UNITED STATES PATENT AND TRADEMARK OFFICE

Office Action Summary

10/511,028

DETAILED ACTION

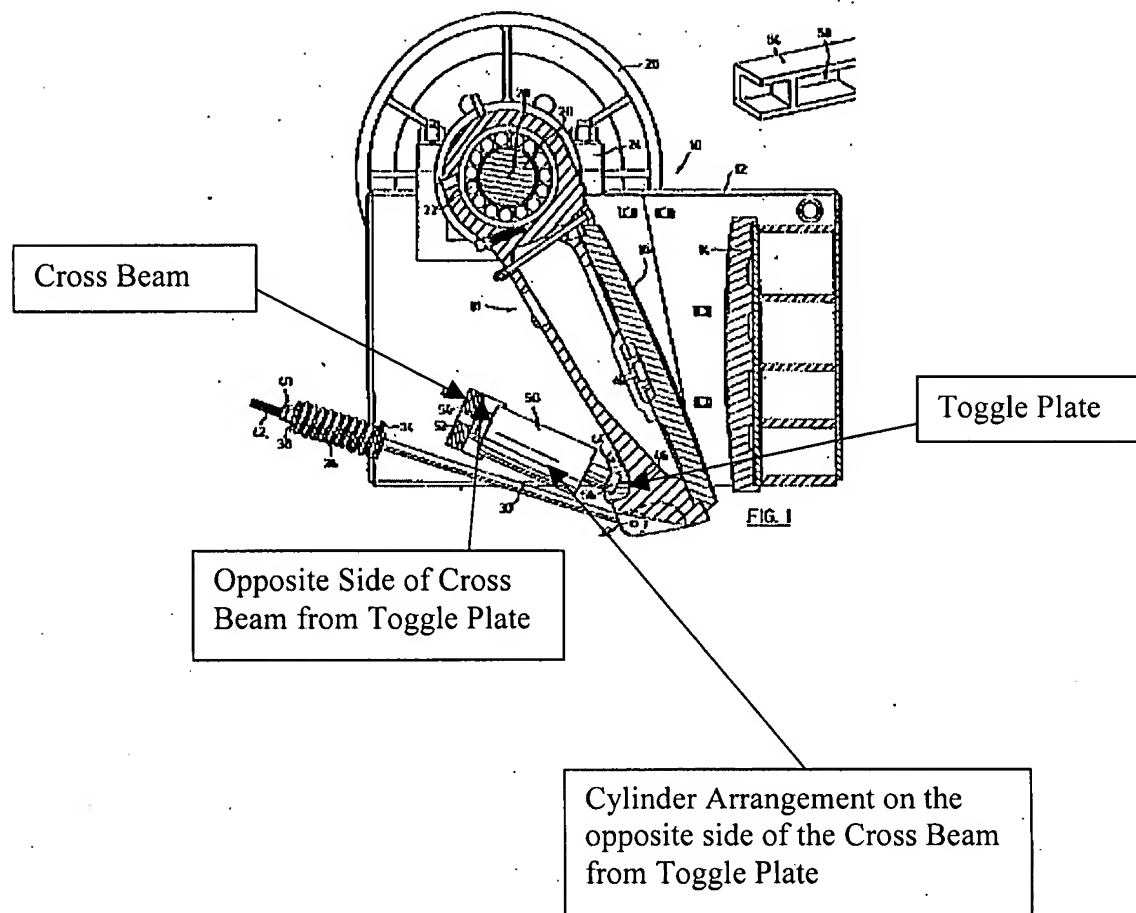
Applicant's arguments filed April 27, 2007 have been carefully considered but they are not persuasive. Applicant's remarks are drawn to the failure of the prior art, Altmayer to disclose a hydraulic cylinder arrangement on the opposite side of the cross beam from the toggle plate. Applicant argues instead that Altmayer teaches the a hydraulic cylinder arrangement (50) arranged intermediate to the toggle plate (44) and therefore not opposite of the cross beam. This argument is not found persuasive, because Altmayer clearly discloses a cross beam (48) that is opposite of the a toggle plate (44), the cross beam (48) having an opposite or opposing side to the toggle plate (44), Altmayer further discloses cylinder arrangement (50) attached or operably coupled to that side of the cross beam that is opposite of the toggle plate.

Although it is Altmayer's inner surface of the cross beam (48) that is opposite of the toggle plate there is no structure within the claimed invention that prohibits the cylinder arrangement from being operably attached at this opposite side, i.e., intermediate. Accordingly, Altmayer discloses the claimed invention and a rejection in view of Altmayer is made.
